Construction and Stormwater Inspection

Operator: NOBLE ENERGY INC - 100322

Location ID: 483510

Inspection Document #: 708201427

Photo 16. See comments in Photo 11.

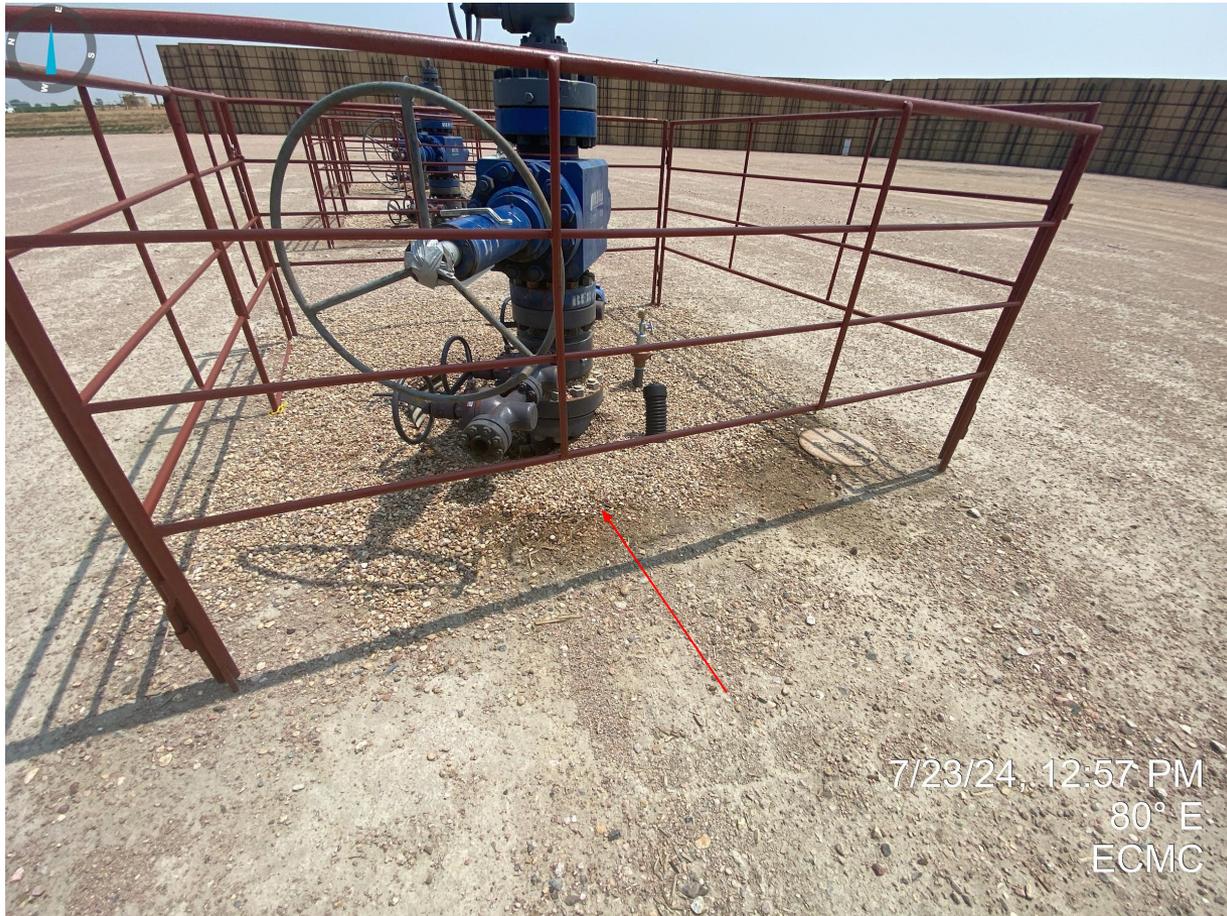
Photo 11. Stained soil observed around conductor at wellhead. Operator shall self inspect all conductors and dispose of stained soils properly.
